### **Allentown Historical Architectural Review Board COA Preliminary Review Sheet**

HDC-2024-00031

Address: 301 N 10th Street

Owner: Julio Blanco **Applicant: Julio Blanco Proposal: Replace siding**

**Proposed Materials (Applicant)**

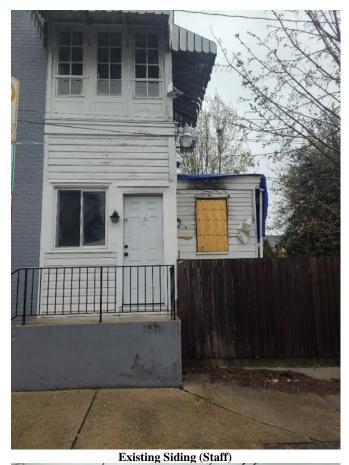
Observations & Comments: It is not clear based on the application the extent of the siding replacement; whether it is the entire rear portions with siding or just areas of damage. It appears there has been fire damage in the rearmost addition and the existing metal siding, which was previously installed to cover existing wood siding has been pulled away. Based on the photographs, it does appear that the existing wood siding remains beneath the metal siding and is largely intact. Replacing siding with a vinyl siding is not historically appropriate per the guidelines. It may be acceptable to replace the metal siding with an in-kind replacement, but per Section 3.2.7, the recommended approach would be removing the existing metal siding that is covering the original wood siding and repairing and repainting the extant wood siding.

**Staff Recommendation:** It is recommended to deny the application.

Action: Mr. Huber made a motion to approve, with conditions, the application presented on May 6, 2024, for the replacement of siding at 301 N 10<sup>th</sup> Street with the following conditions agreed to by the application following sections of the Guidelines for Historic Districts: Chapter 3, Section 3.2 – Wood Siding & Trim and find that there are no circumstances unique to the property:

- Repair wood siding and paint.
- Repair broken windows (replace glass) and paint.
